# LCS ENCODER / MASTER BOARD

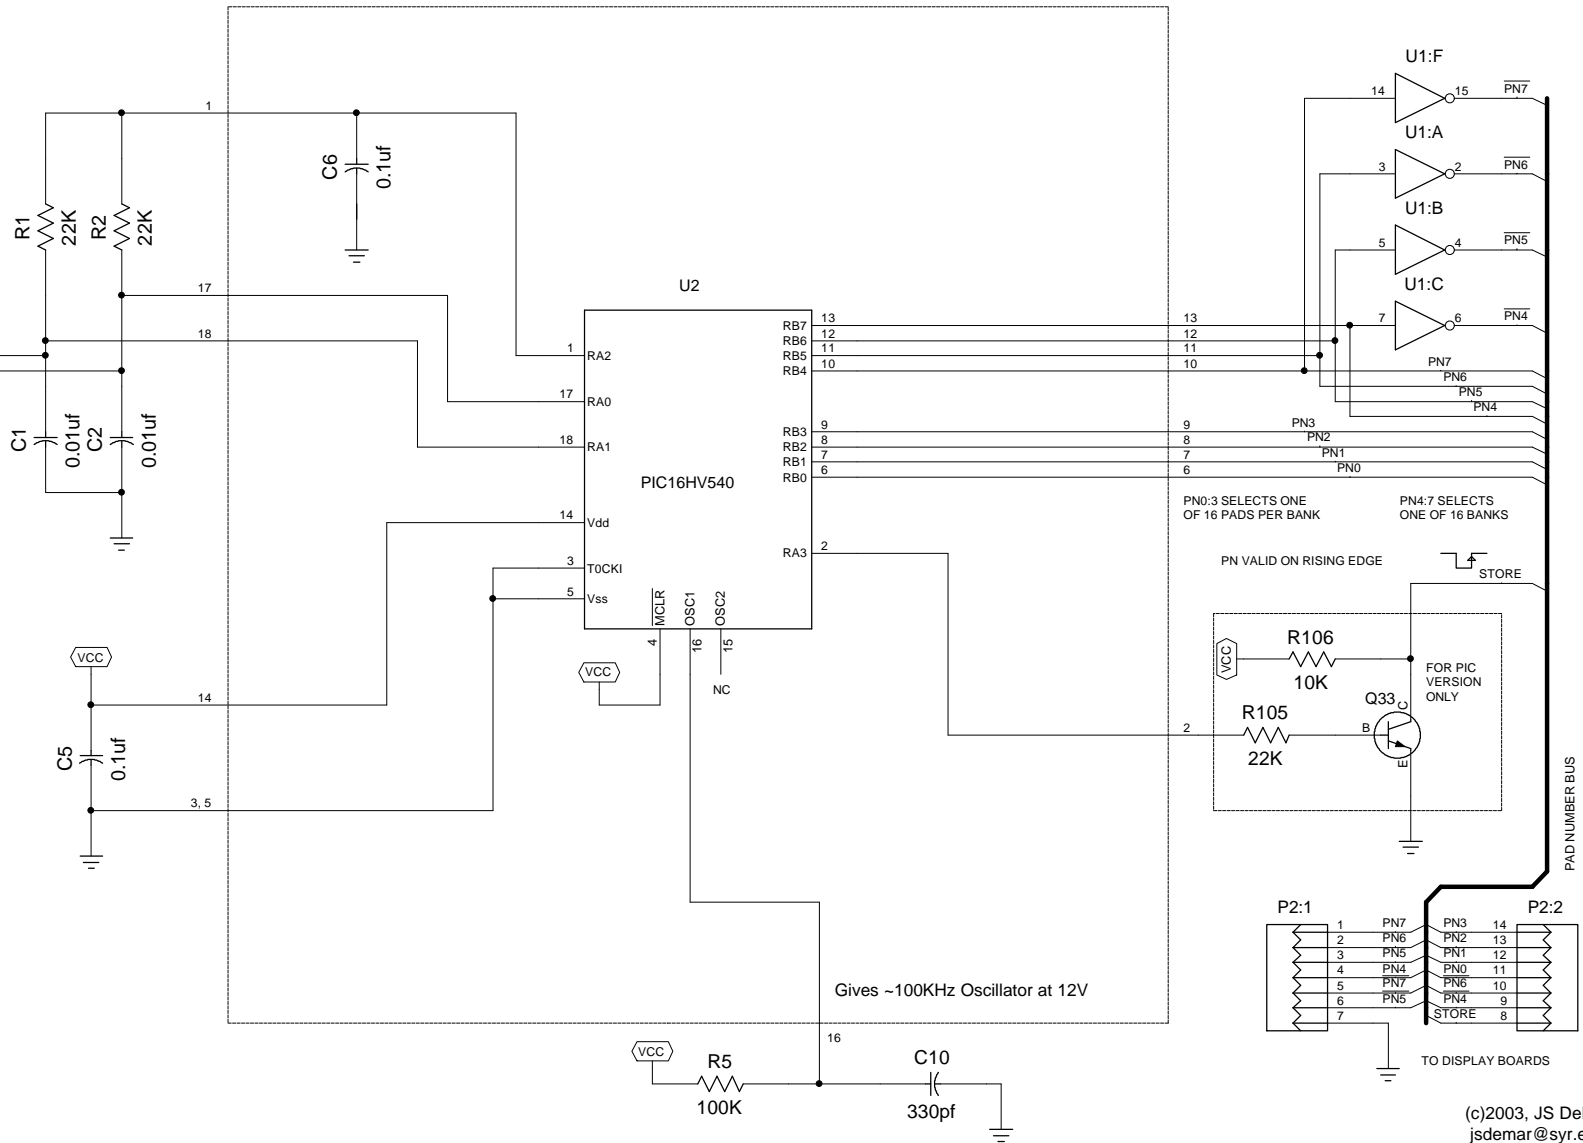
Rev. 01/05/2003  
 Added: C6  
 Changed: C10 to 330pf  
 Changed: C1, C2 to 0.01uf

PIC16HV540 REPLACES FIXED LOGIC

# LCS ENCODER / MASTER BOARD

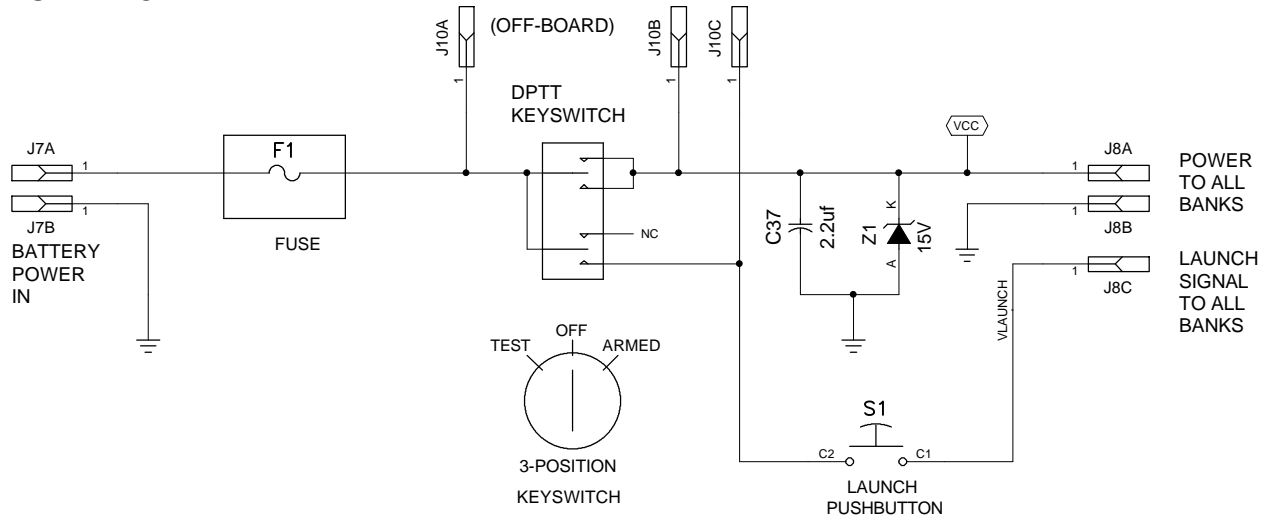
Rev. 01/05/2003  
 Changed PIEZO to VCC  
 Changed R109 to 560

-- OR REPLACE WITH TWO SWITCHES:  
 ONE FOR OVERALL POWER (VCC) AND  
 ONE FOR ARMING POWER (VLAUNCH)
